# City Of Torrington

## ADDENDUM No. 1

**RE: Torrington Drainage and Associated Improvements (Various Locations)**

**BID No. DAI-027-051117**

Drawn PJKK  
 Checked: EF  
**SHEET NO. D2**

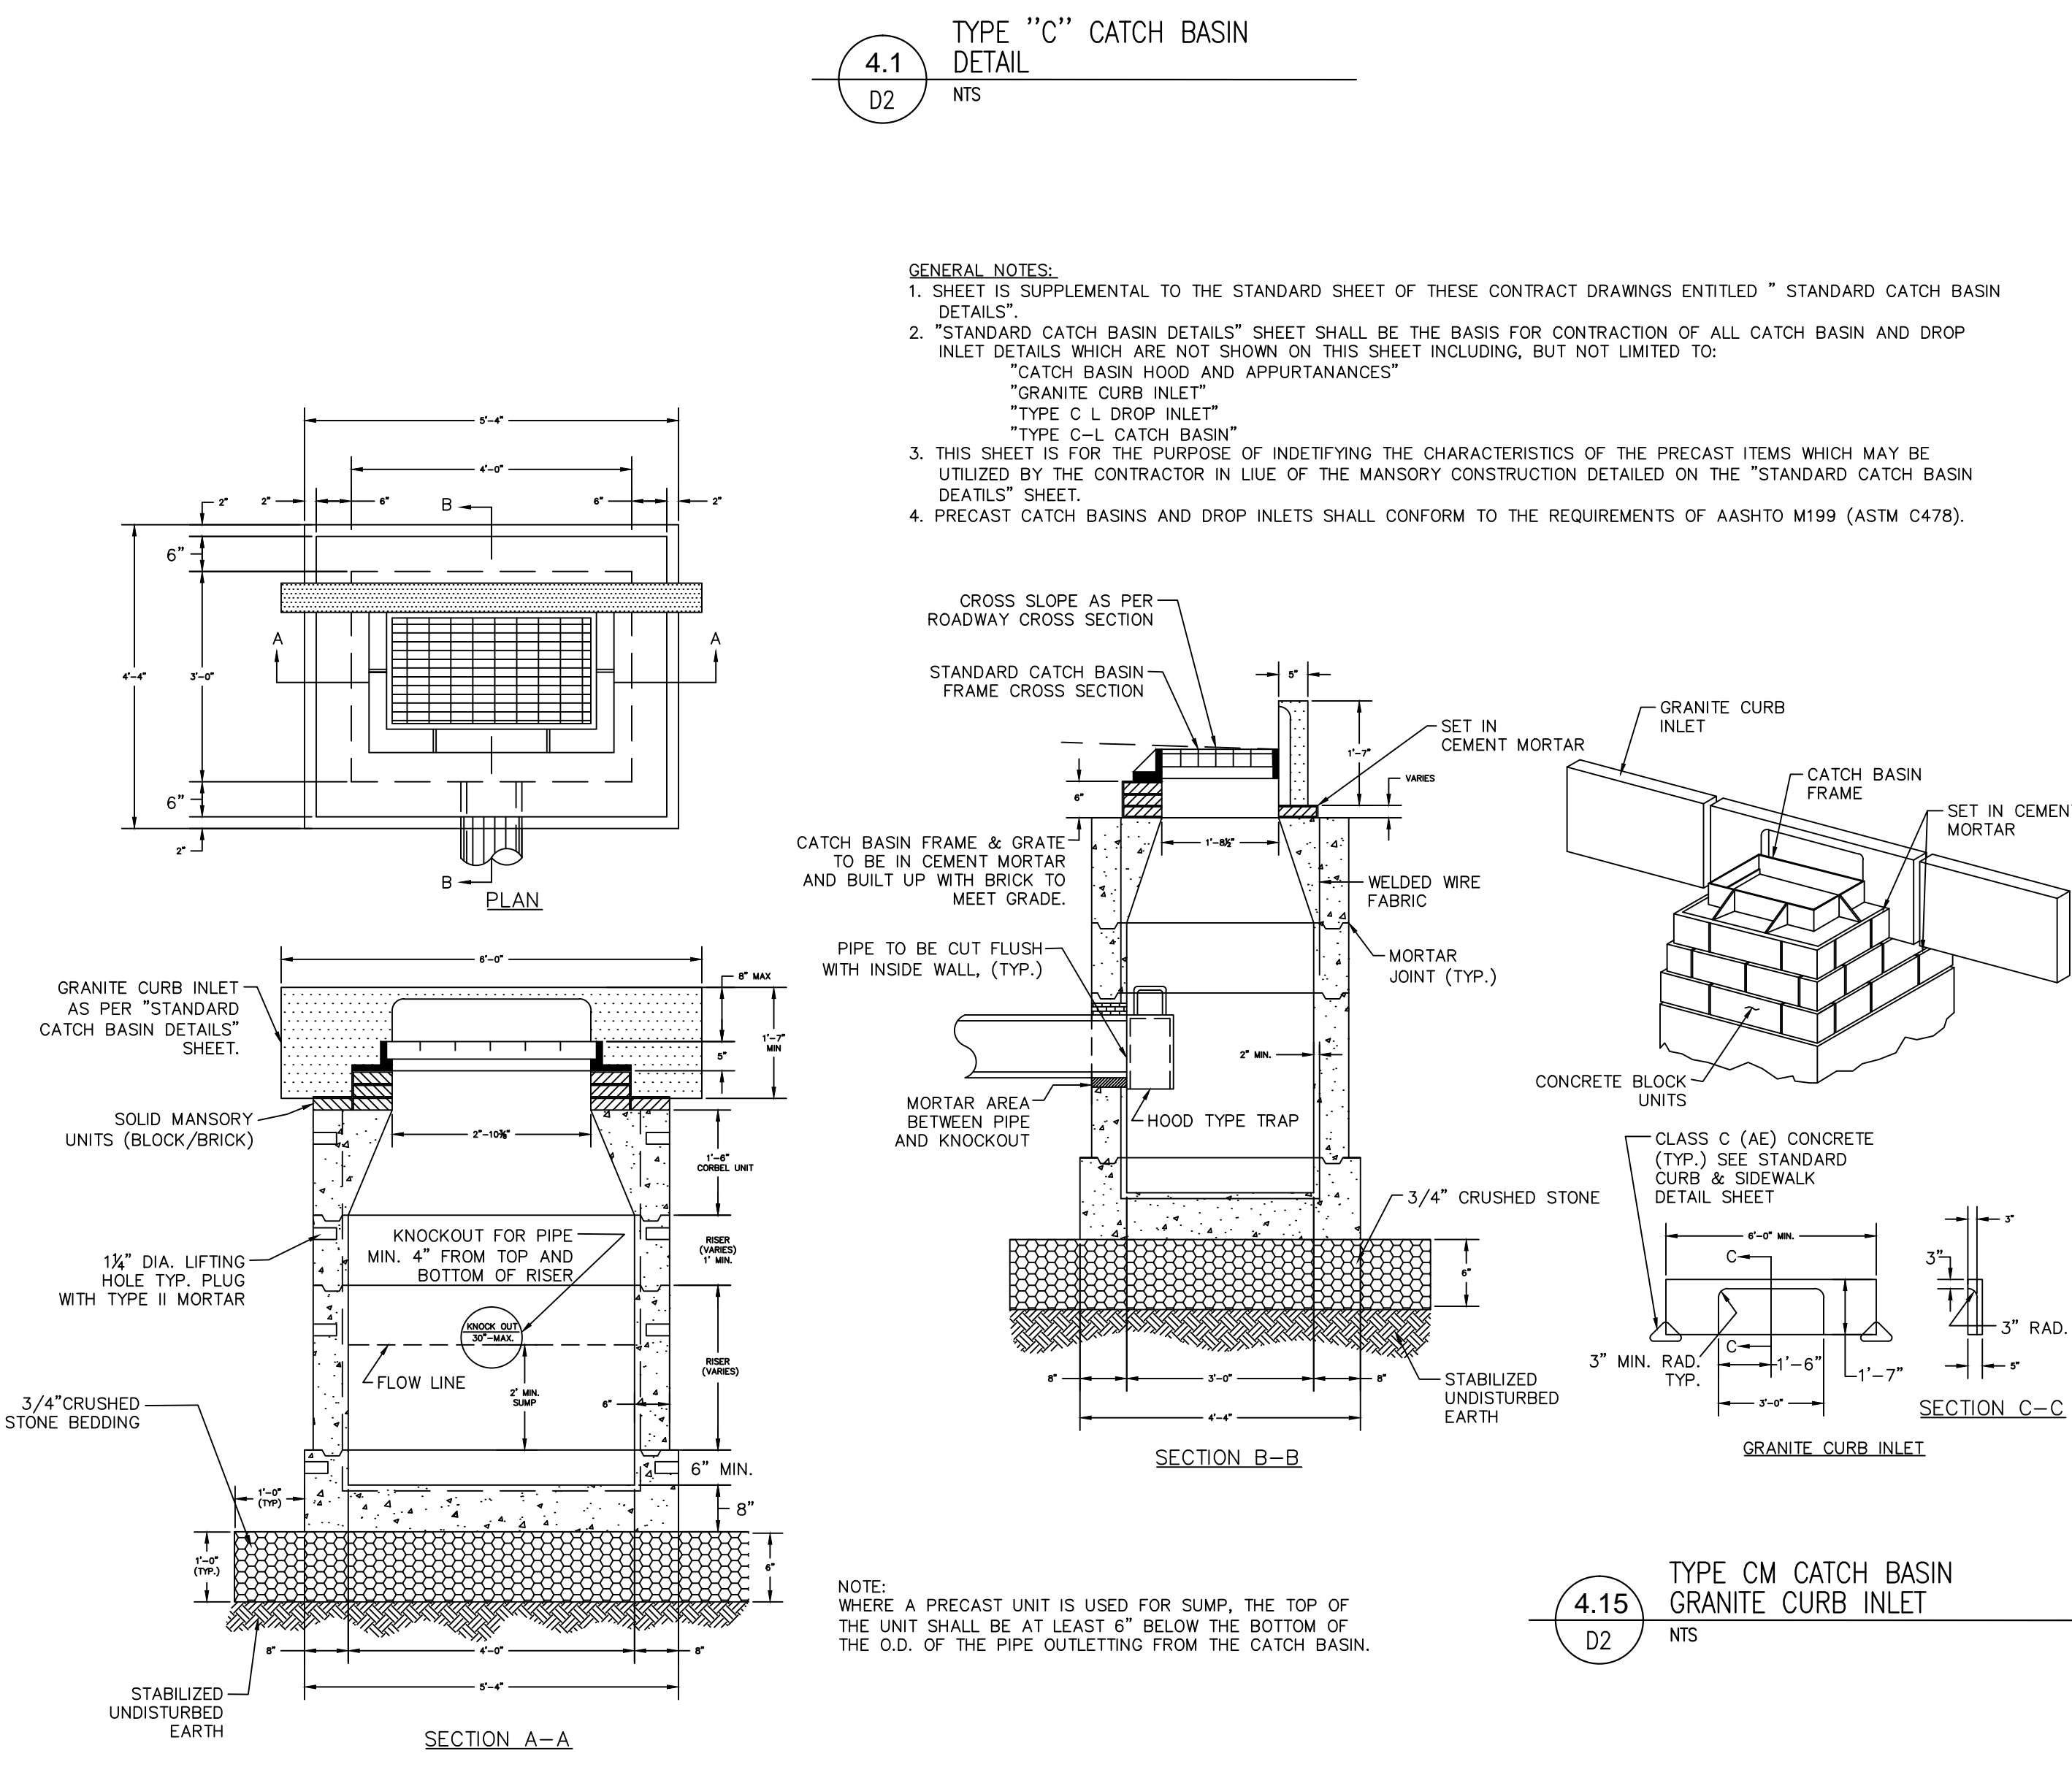
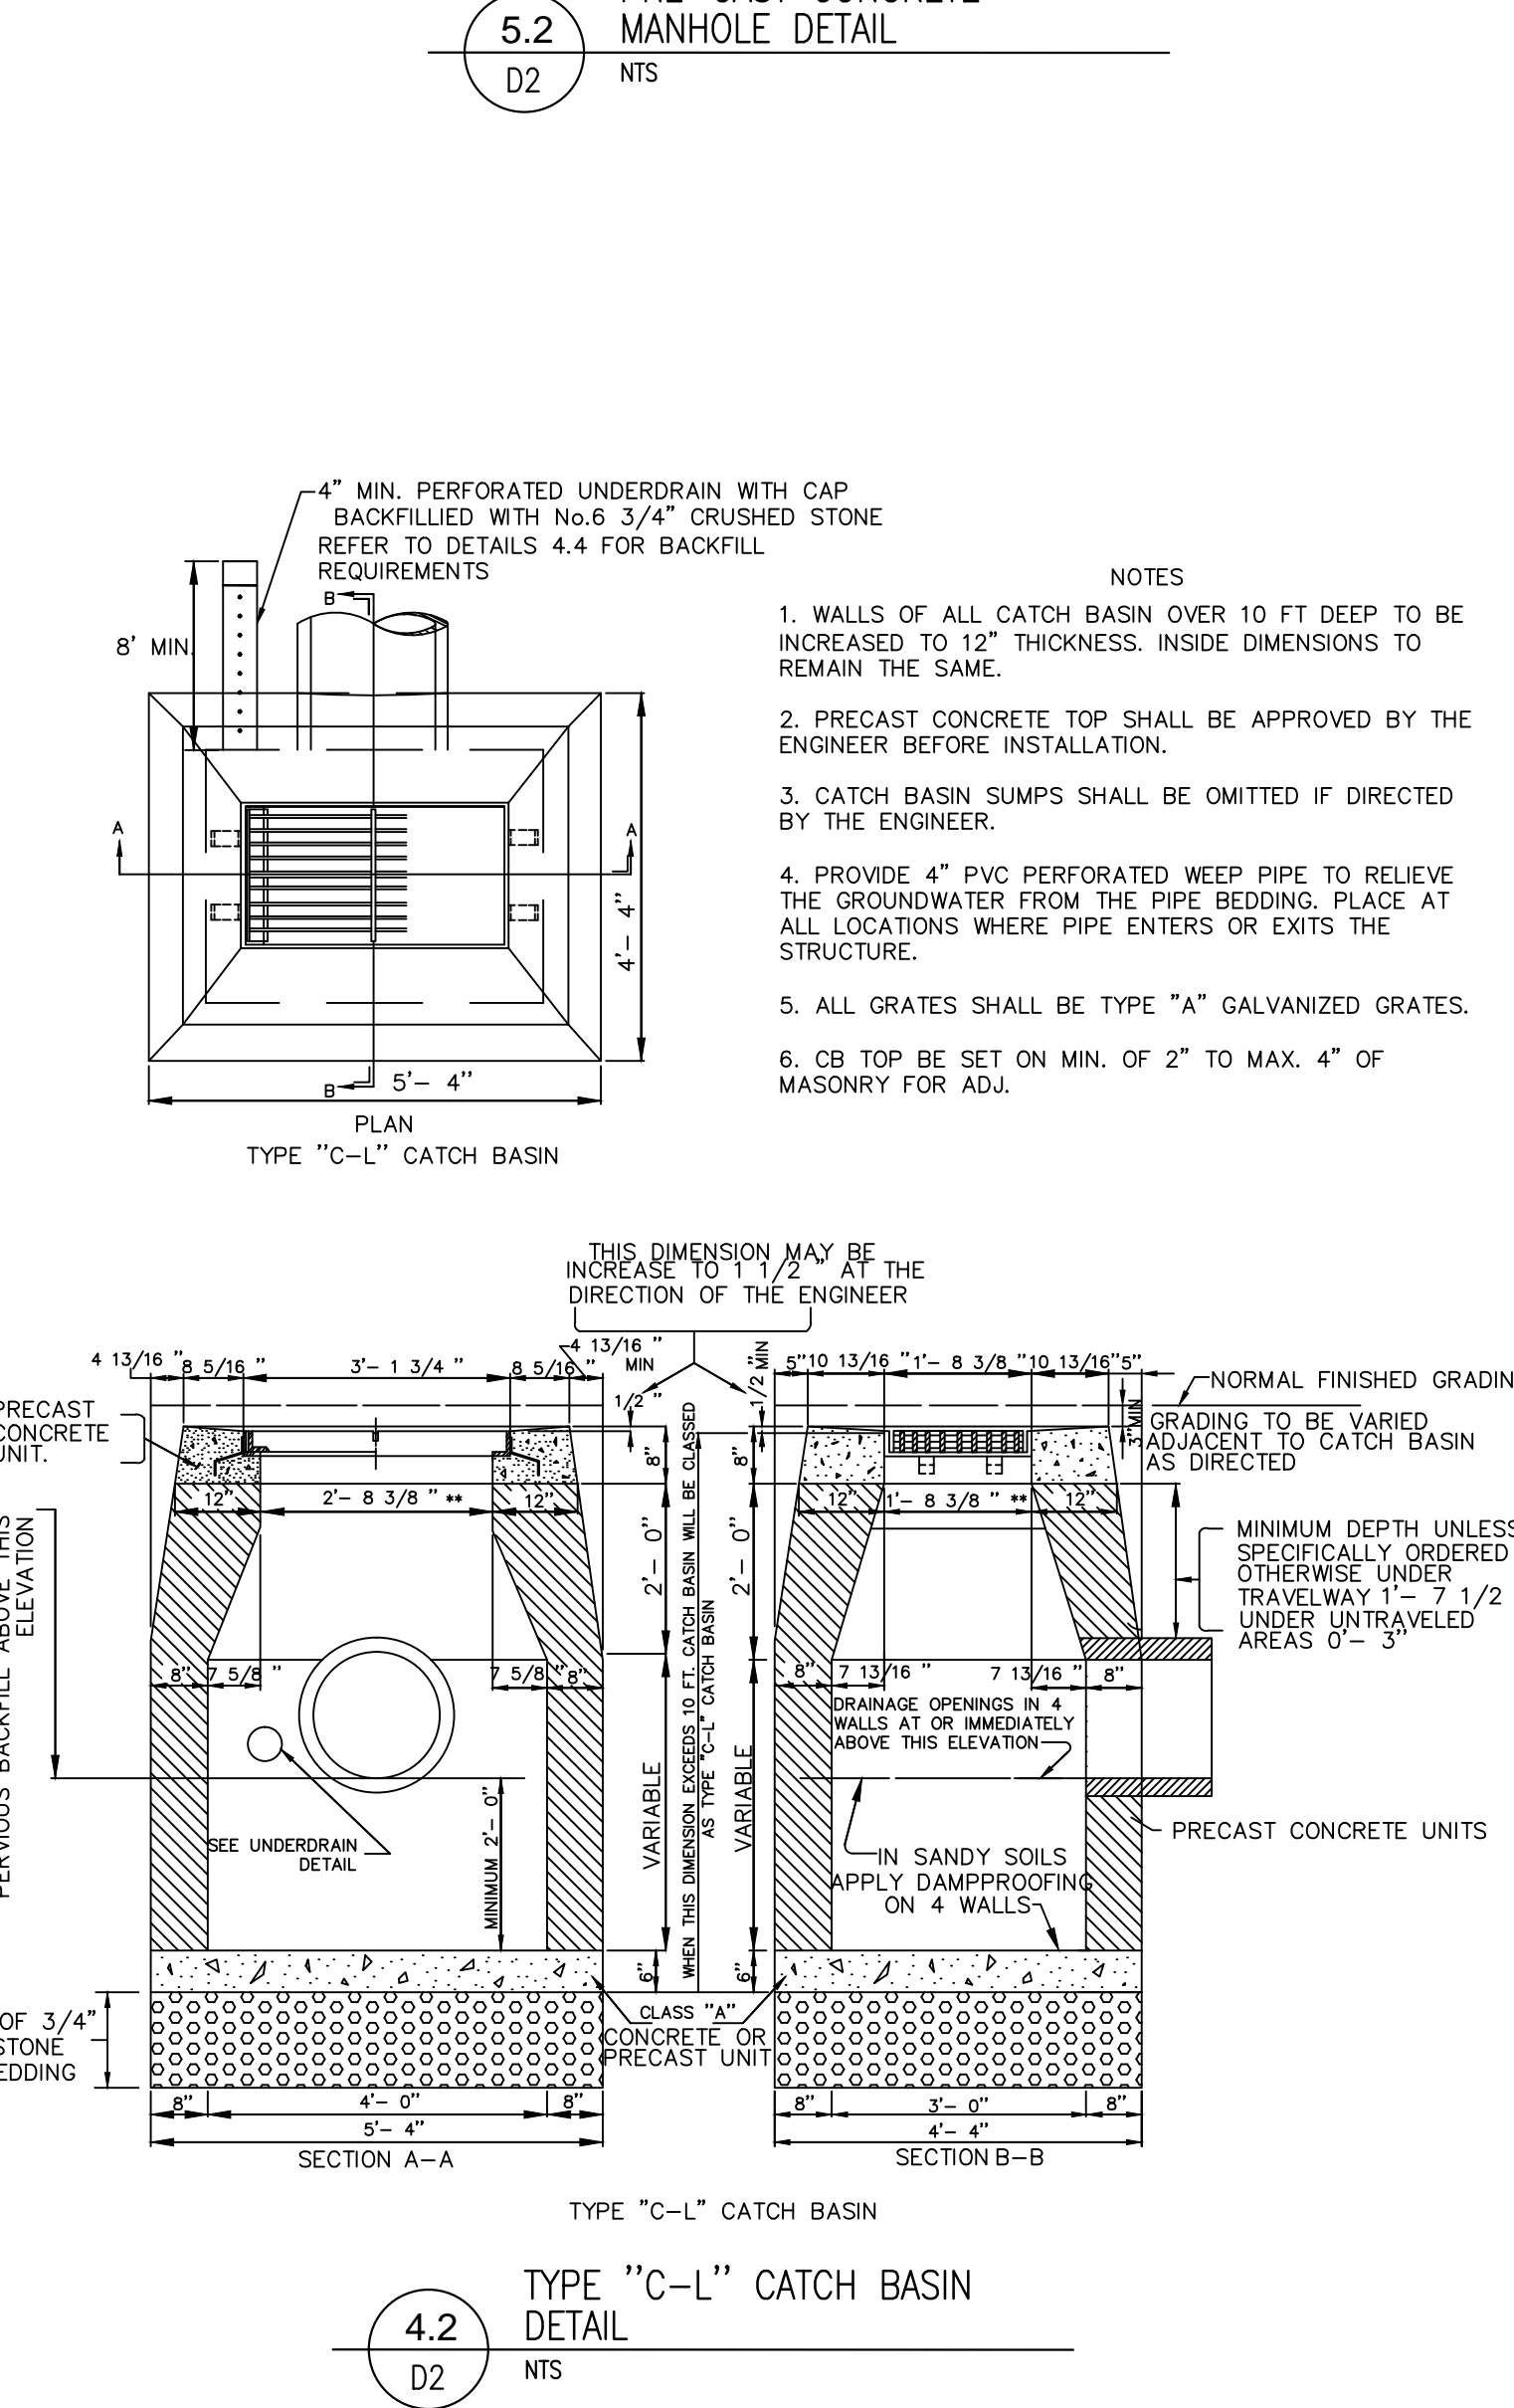
- EXISTING STONE CULVERT UNDER PROSPECT STREET - CONNECT TO EXISTING (REVISION 1)**  
 -THE EXISTING 48"x60" STONE CULVERT UNDER PROSPECT STREET CONNECTS TO AN EXISTING CULVERT STRUCTURE WITH BENCHED 30" HALF PIPE BOTTOM, NEW PR-CB(M1) SHALL BE CONNECTED TO THE DOWNSTREAM OPENING BY WAY OF A TRANSITION SECTION PR-JCT(M1) BY PROVIDING A SHORT SECTION OF 36" HDPE PIPE PR-STP(M10) WITH CAST IN PLACE (C-I-P) CONCRETE COLLAR TO SEAL ALL VOID OPENINGS AROUND THE NEW PIPE. THE NEW C-I-P CONCRETE COLLAR SHALL ENCLOSE THE EXISTING STRUCTURE OPENINGS AND THE OUTSIDE OF THE NEW CONNECTING PIPE PR-STP(M10) BY AT LEAST 2 FEET IN ALL DIRECTIONS. THIS COLLAR SHALL BE WATERTIGHT AND STRUCTURALLY SOUND TO SUPPORT THE ABOVE ROAD AND SIDEWALK. WORK FOR THIS CONNECTION SHALL BE CONSIDERED PART OF THE REMOVAL WORK AND INCLUDED IN THE LUMP SUM CLEARING AND DEMOLITION ITEM.

- EXISTING SIGNS (REVISION 1)**  
 -WHERE EXISTING SIGN ARE WITHIN LOCATED WITHIN THE AREA OF INSTALLATION WORK, CONTRACTOR SHALL REMOVE SIGNS AND POST PRIOR TO CONSTRUCTION AND REPLACE ALL SIGNS AND POSTS IN SAME LOCATION AFTER CONSTRUCTION. SIGNS SHALL BE RELACED ON NEW POSTS AND BASES. POSTS AND BASES SHALL BE REPLACED WITH NEW MATERIALS. ALL INSTALLATION WORK SHALL MEET COT SPECIFICATIONS.

- CATCH BASINS (REVISION 1)**  
 -ALL CATCH BASINS SHALL HAVE NO OR MINIMUM SUMP DEPTH. PIPE OPENINGS ARE TO BE MADE IN RISER WALLS WITH MINIMUM WALL DEPTH UNDER PIPES ONLY TO PROVIDE STRUCTURAL INTEGRITY OF THE RISER.
